Smith Ranch-Highland
Operation

NSR for Monitor Well KMO-007 UCL Adjustments, Cameco Resources, Smith Ranch-Highland Uranium Project, Permit 603 and 633

INDEX SHEET FOR MINE PERMIT AMENDMENTS OR REVISIONS

KMO-007

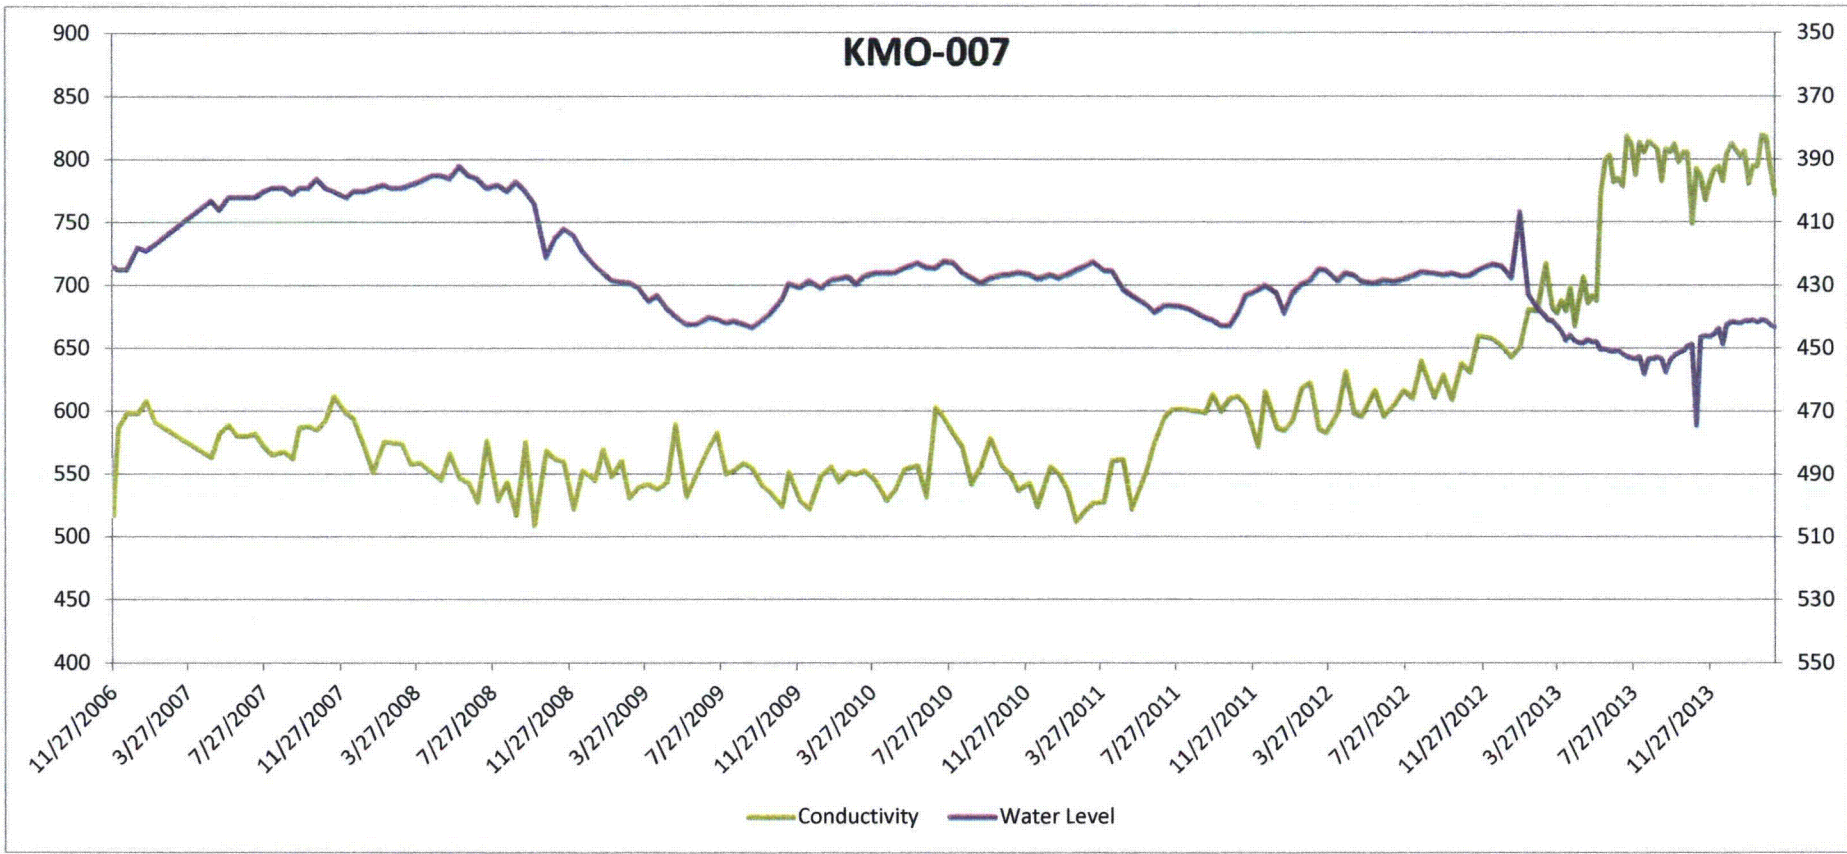
- February 20, 2014 - Cameco presented proposed UCL adjustments for Monitor Well KMO-007, together with graphs demonstrating stability in the parameter concentrations. Graphs for water quality in adjacent wells, KMO-006 and KMO-008, were also presented to again demonstrate that they are not being affected and that the concentration increase is isolated to KMO-007. Attached are the table and graphs presented to LQD.

Using this strategy, the new internal limits for Monitor Well KMO-007 will be 14 for Chloride, 249 for Alkalinity and 810 for Conductivity. As can be seen in the attached table these limits are just higher than the average of each parameter used for the proposed UCL calculations. This will ensure that should Monitor Well KMO-007 start to trend upward, the well would immediately be flagged and assessed.
